The Chalets at Ski Lake Phase 8

A Cluster Subdivision

Plan / Profile (Utility)
The Chalets at Ski Lake No. 8
 A part of the Southwest 1/4 of Section 13, a part of the Northeast 1/4 of Section 23, and a part of the Northwest 1/4 of Section 24, 1/4 of Section 25, T6N, R1E, S18&M, U.S. Survey

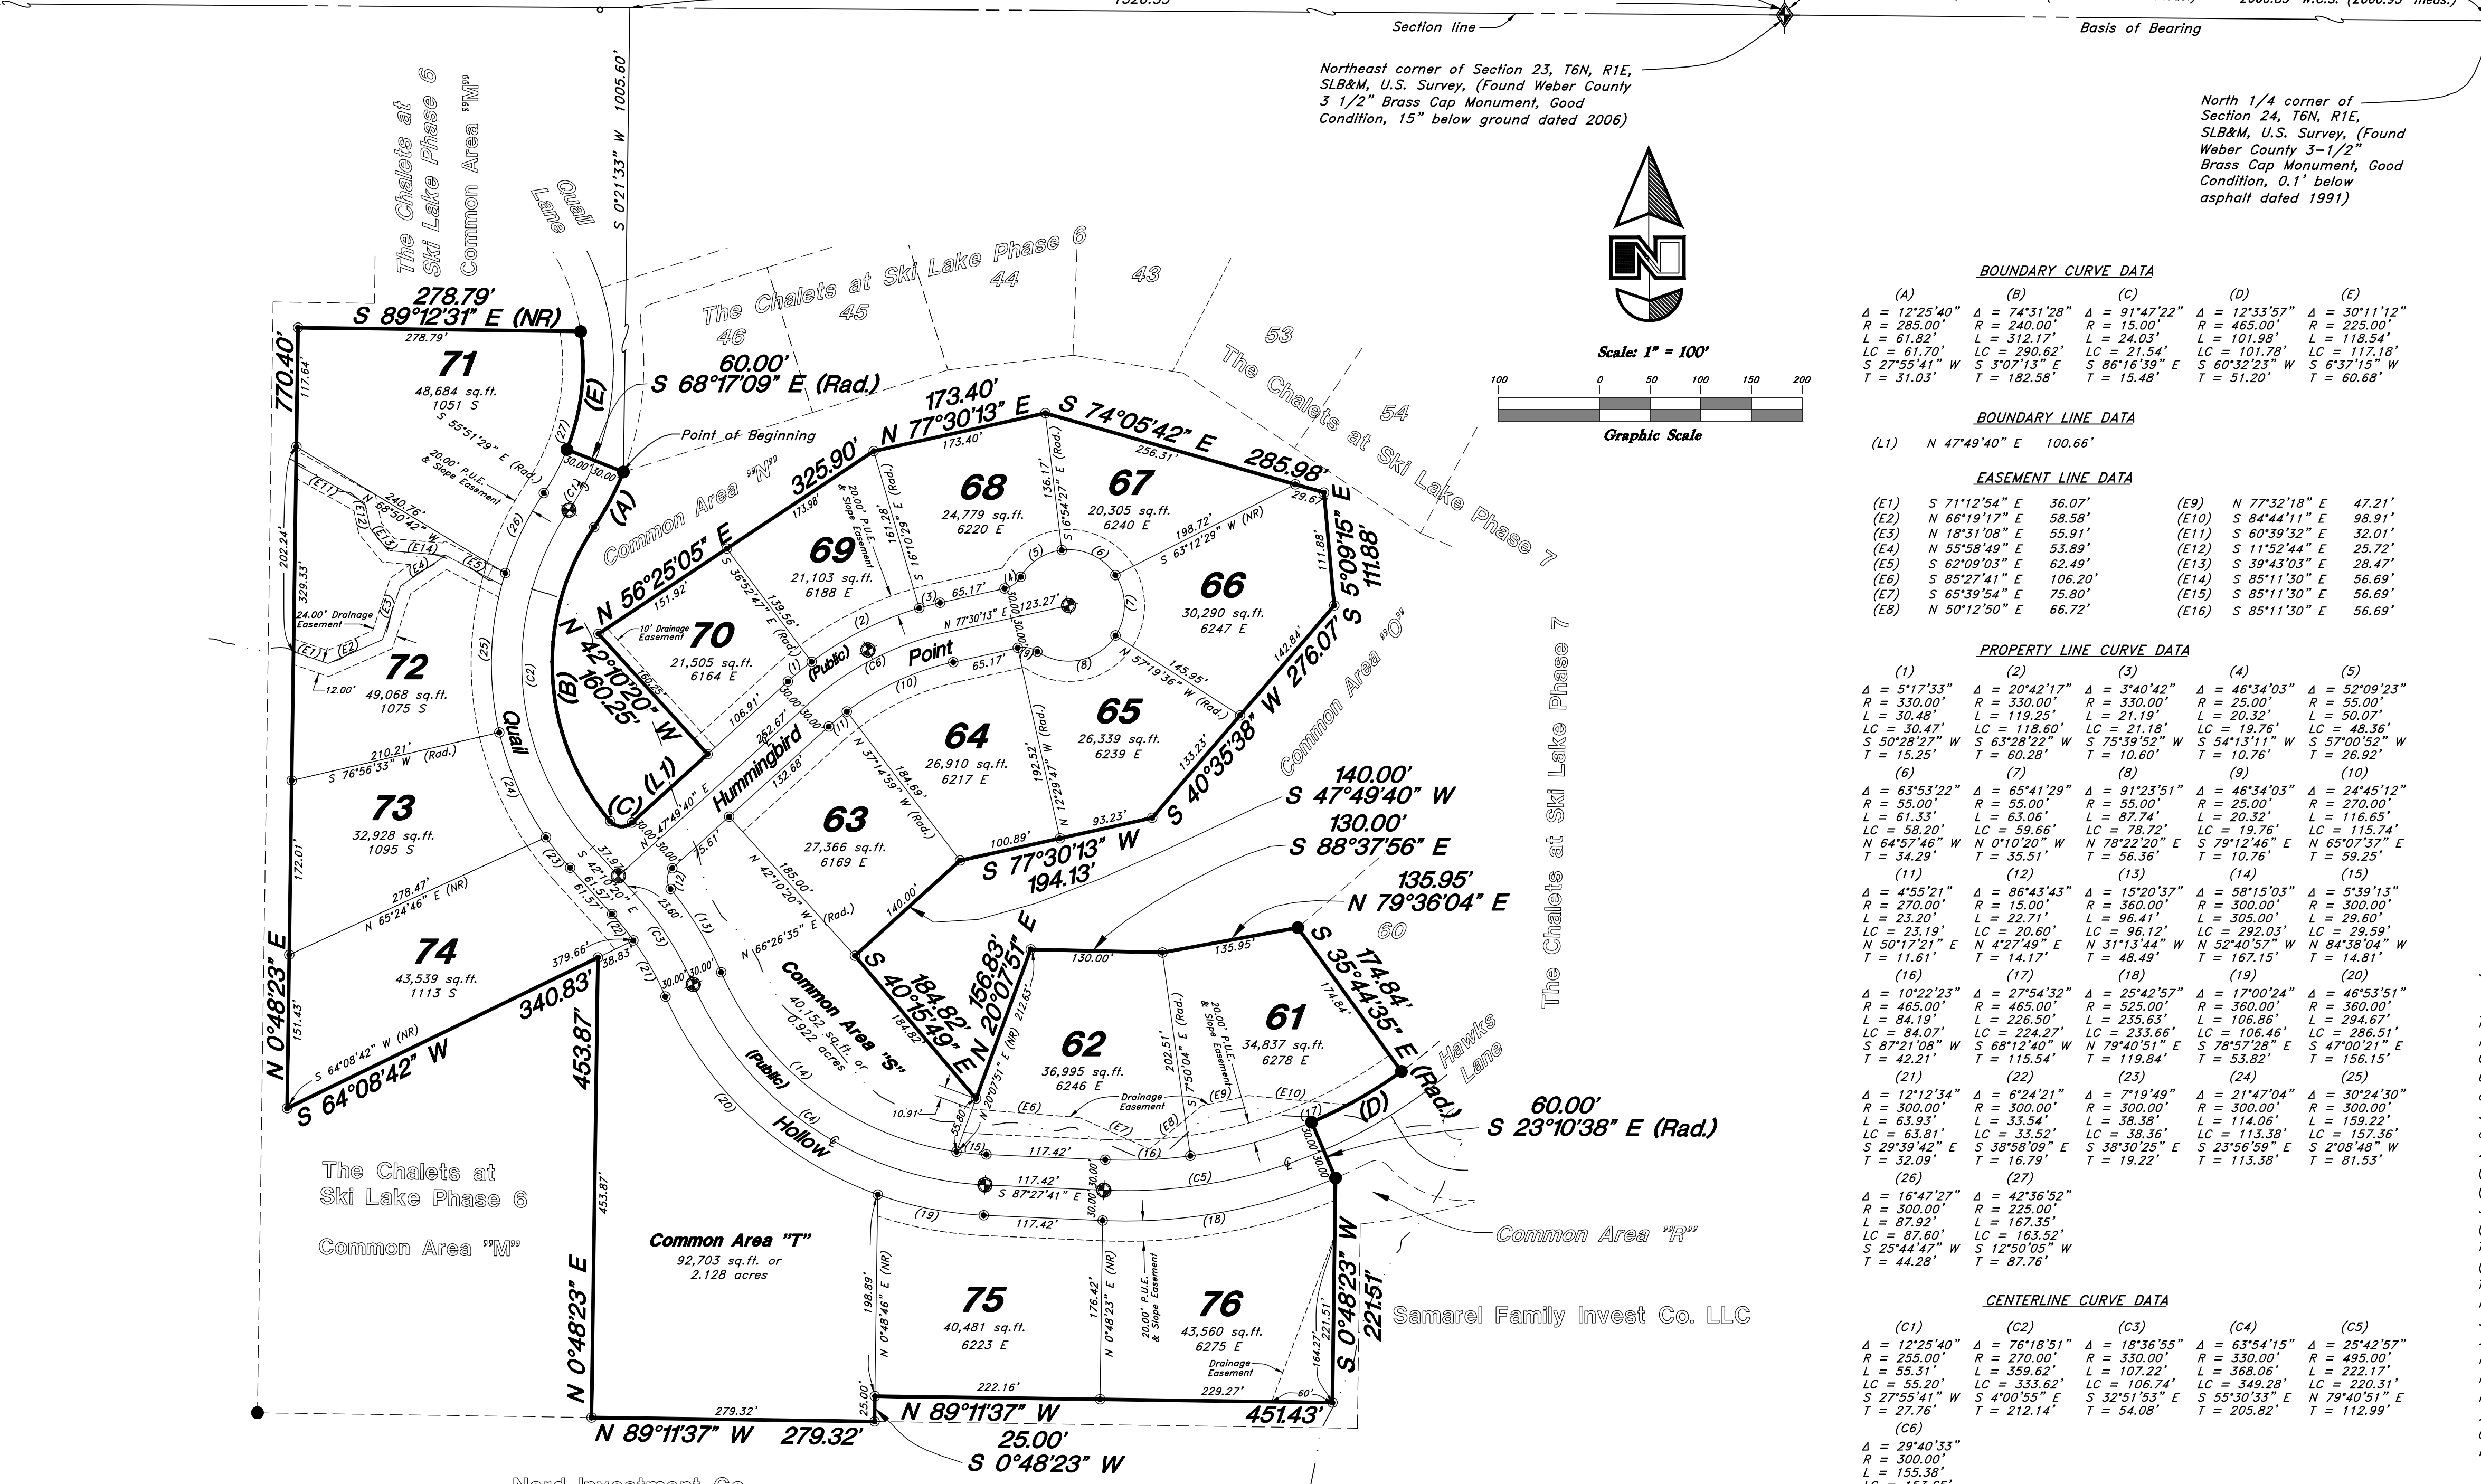
I think this note should be the same as the one on Ph7 Plat.

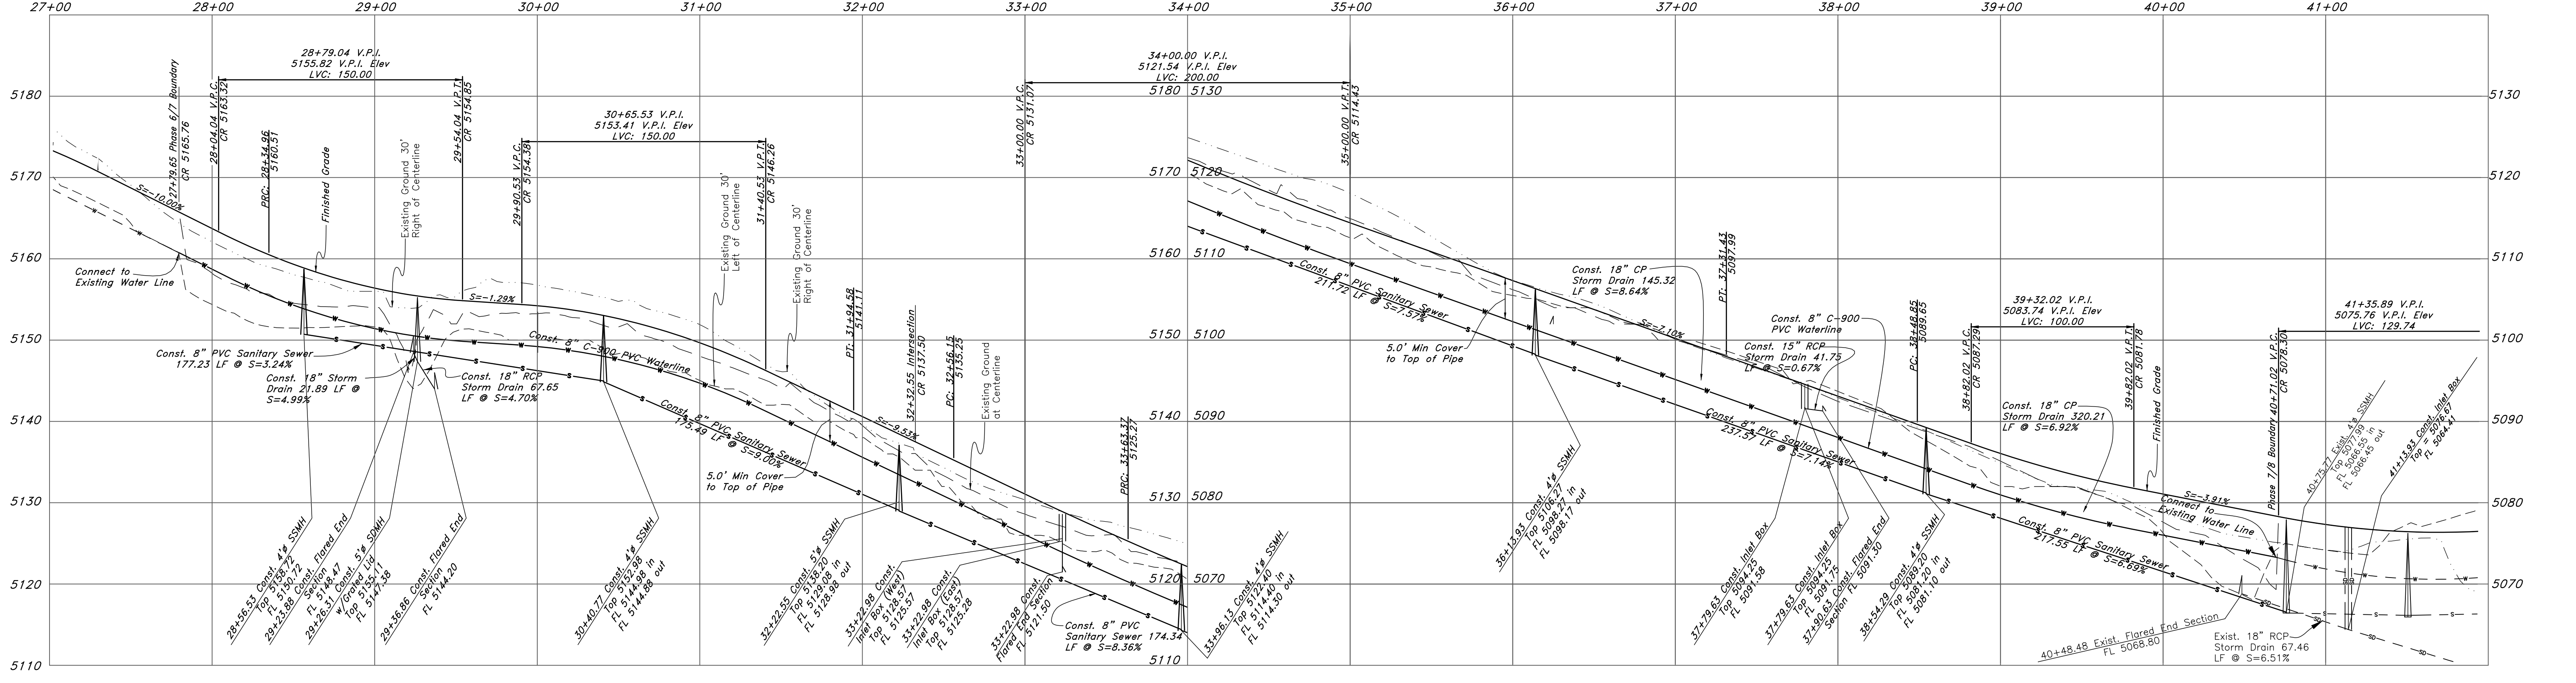
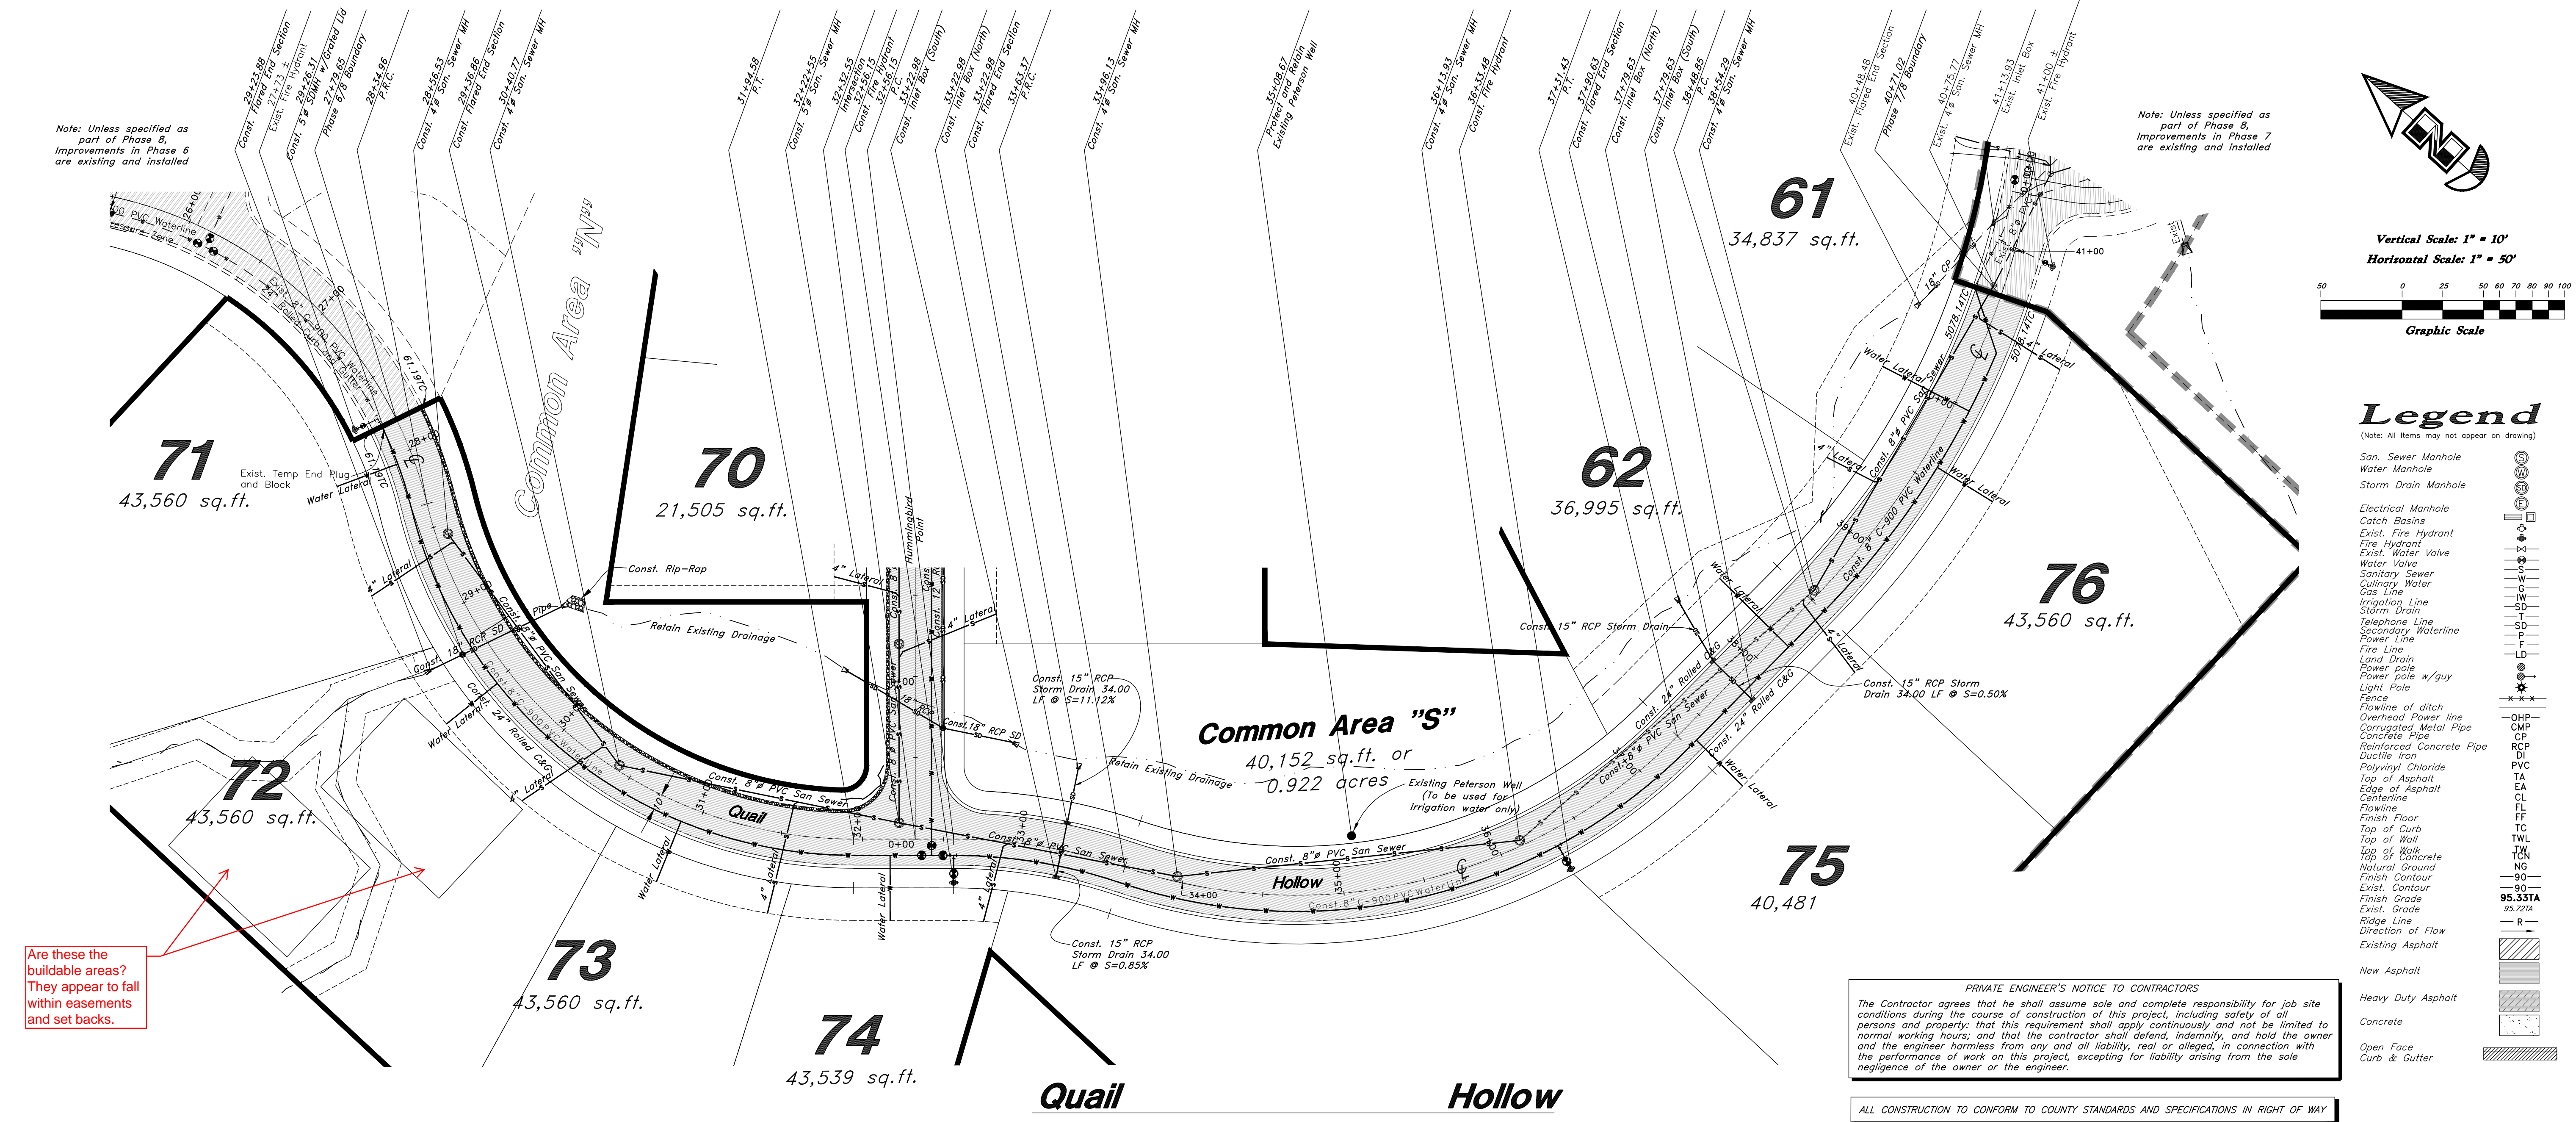
Are these the buildable areas? They appear to fall within easements and set backs.

10 Typical Pavement Section

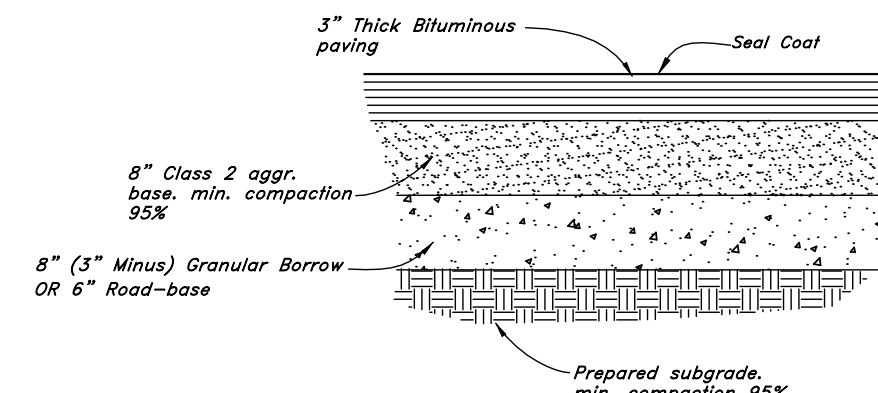
This is different than the roadway section of 8" of base and 8" of sub-base.
